**Redegørelse i anledning  
af tre havarier  
med Dash8 Q400**

**Bilag til redegørelsens kap. 6**

**Hæfte 1**

Retraction actuator assembly p/n 46550-7/-9

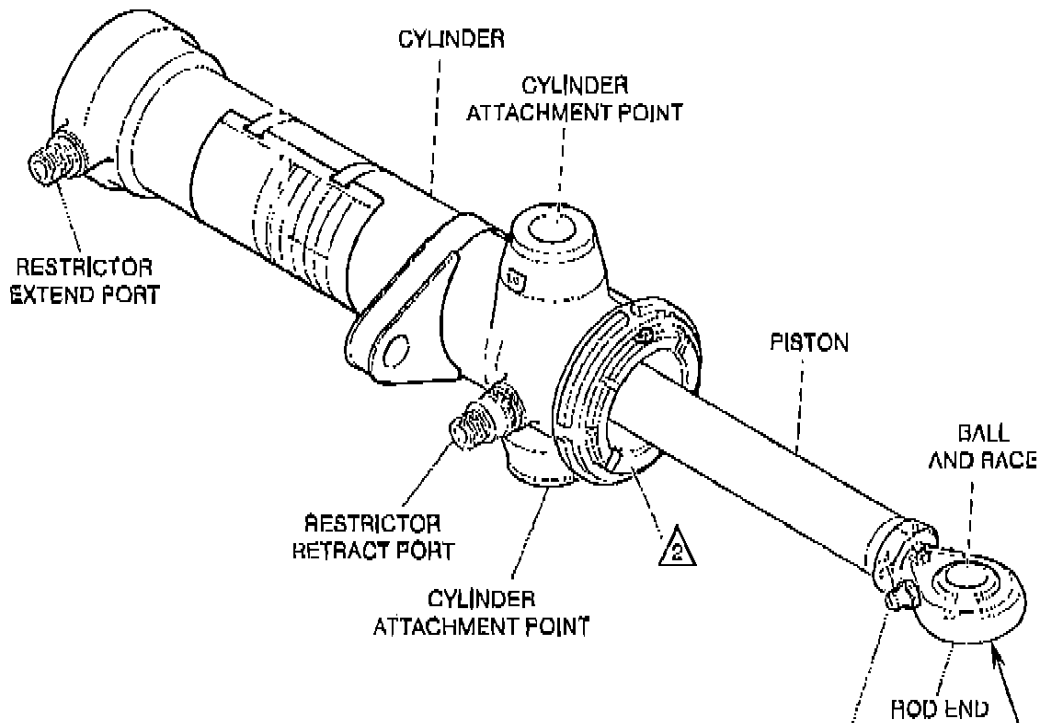
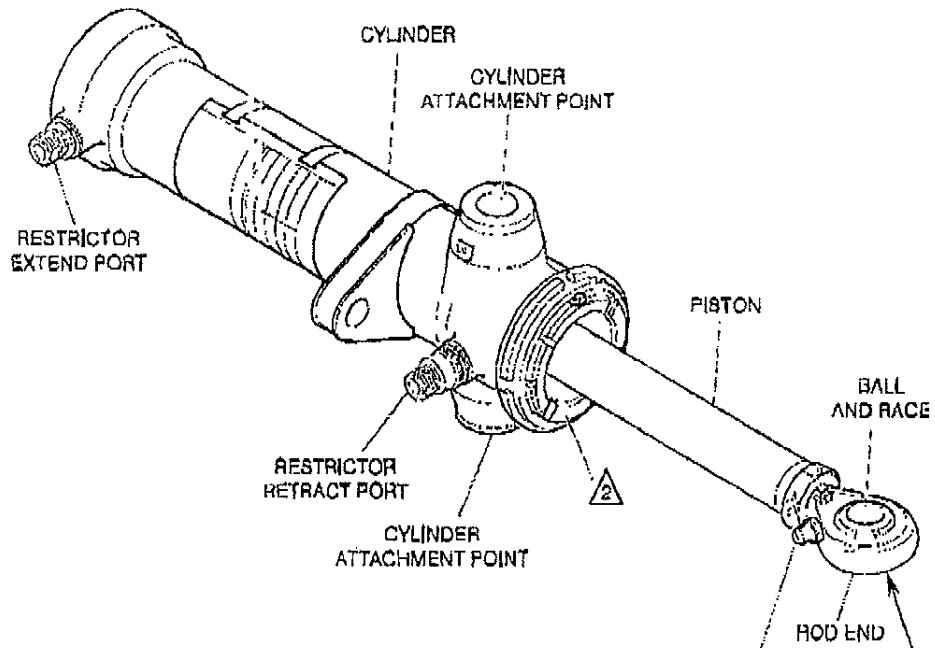
Remove the rod end of the retraction actuator assembly in accordance with SCR 086-07 rev. ~~REV~~ A.

Remove the rod end of the retraction actuator assembly in accordance with SCR 086-07 rev. ~~A~~ B

No corrosion or wear damage is allowed, EXCEPT AS NOTED IN SCR 086-07 REV. ~~A~~ B  
 Provided the components are free of any damage re-assemble retraction actuator in accordance with SCR 086-07 rev. ~~A~~ B

**FIGURE 1**

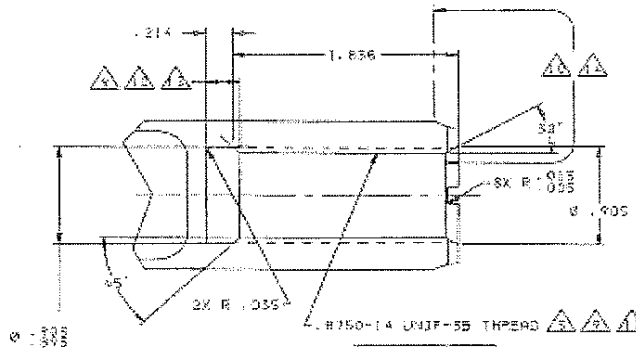
1. DISASSEMBLE AS REQUIRED TO REMOVE ROD END P/N P3A2750 FROM ACTUATOR ASSEMBLY.
2. INSPECT - ENSURE NO EVIDENCE OF CORROSION ON ACTUATOR PISTON THREADS OR ROD END THREADS.
3. COAT ACTUATOR THREADS AND THREAD RELIEF AS WELL AS ROD END THREADS, WITH CIC MASTINOX 6856K OR CORBAN 27L, AND RE-INSTALL ROD END ONTO ACTUATOR ASSEMBLY.
4. ADJUST ACTUATOR RETRACTED LENGTH USING TOOL CG 56806 REQUIREMENTS OR IN ACCORDANCE WITH CMM 32-31-06 REQUIREMENTS. OPTIONAL PROCEDURE PER STEP 13, ABOVE, IS ALSO ACCEPTABLE
5. TORQUE JAM NUT TO 660-980 IN-LBS AND SAFETY LOCKWIRE PER MS 33540.

**FIGURE 2**

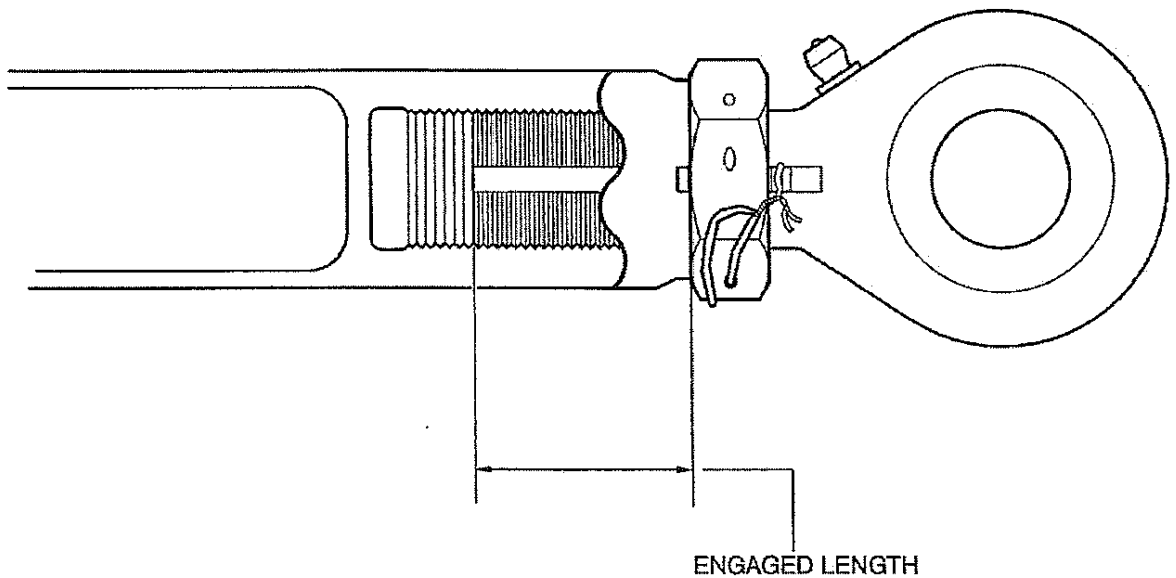
- 4. ACCEPTANCE CRITERIA**
- A) LIGHT SURFACE CORROSION (NO PITTING) OVER THE ENTIRE THREADED LENGTH WITH AT LEAST FIVE CONSECUTIVE FULL UNDAMAGED THREADS WITHIN THE ENGAGED THREAD LENGTH (REF FIGURE 2) IS ACCEPTABLE FOR **1000 FC OR 6 MONTHS** (WHICH EVER OCCURS FIRST) OF CONTINUED SERVICE. RETRACT ACTUATOR TO BE INSPECTED TO ENSURE JAM NUT IS SECURE AND WIRE LOCK IS IN PLACE EVERY **100 FC**.

- B) EVIDENCE OF MODERATE TO SEVERE PITTING CORROSION BEYOND CRITERIA STATED IN A). MUST BE REPAIRED PER SALVAGE DRAWING S2116 OR REPLACED.

**FIGURE 1**

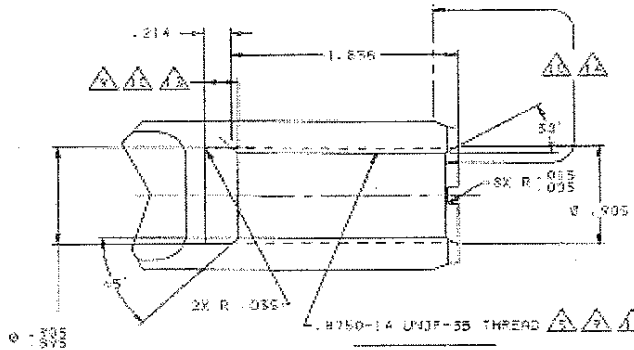
1. DISASSEMBLE AS REQUIRED TO REMOVE ROD END P/N P3A2750 FROM ACTUATOR ASSEMBLY.
2. INSPECT - ENSURE NO EVIDENCE OF CORROSION ON ACTUATOR PISTON THREADS OR ROD END THREADS.
3. COAT ACTUATOR THREADS AND THREAD RELIEF AS WELL AS ROD END THREADS, WITH CIC MASTINOX 6856K OR CORBAN 27L, AND RE-INSTALL ROD END ONTO ACTUATOR ASSEMBLY.
4. ADJUST ACTUATOR RETRACTED LENGTH USING TOOL CG 56806 REQUIREMENTS OR IN ACCORDANCE WITH CMM 32-31-06 REQUIREMENTS. OPTIONAL PROCEDURE PER STEP 13, ABOVE, IS ALSO ACCEPTABLE
5. TORQUE JAM NUT TO 660-980 IN-LBS AND SAFETY LOCKWIRE PER MS 33540.

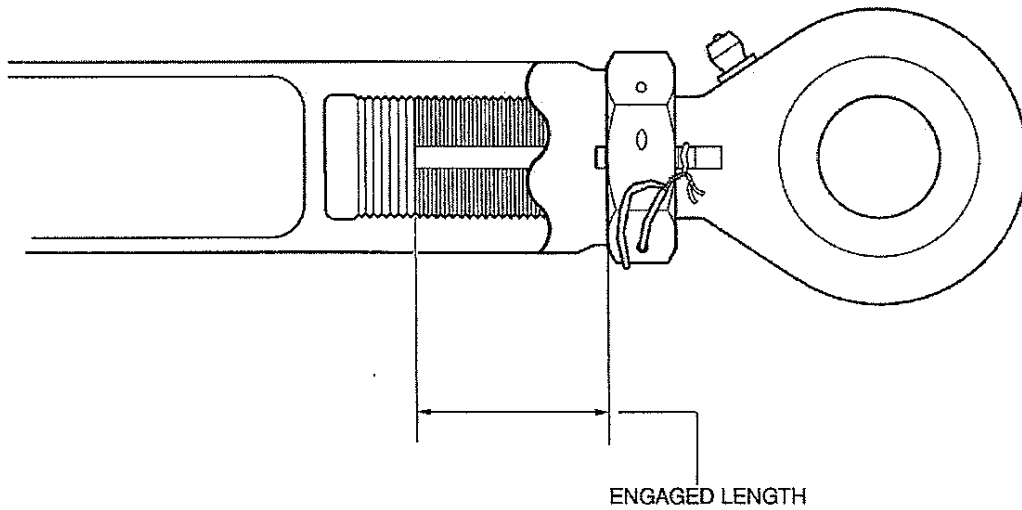
4. **ACCEPTANCE CRITERIA/REWORK OPTIONS**
  - A) LIGHT SURFACE CORROSION (NO PITTING) OVER THE ENTIRE THREADED LENGTH WITH AT LEAST FIVE CONSECUTIVE FULL UNDAMAGED THREADS WITHIN THE ENGAGED THREAD LENGTH (REF FIGURE 2) IS ACCEPTABLE FOR **1000 FC OR 6 MONTHS** (WHICH EVER OCCURS FIRST) OF CONTINUED SERVICE. THE RETRACT ACTUATOR IS TO BE INSPECTED TO ENSURE JAM NUT IS SECURE AND WIRE LOCK IS IN PLACE EVERY **100 FC**
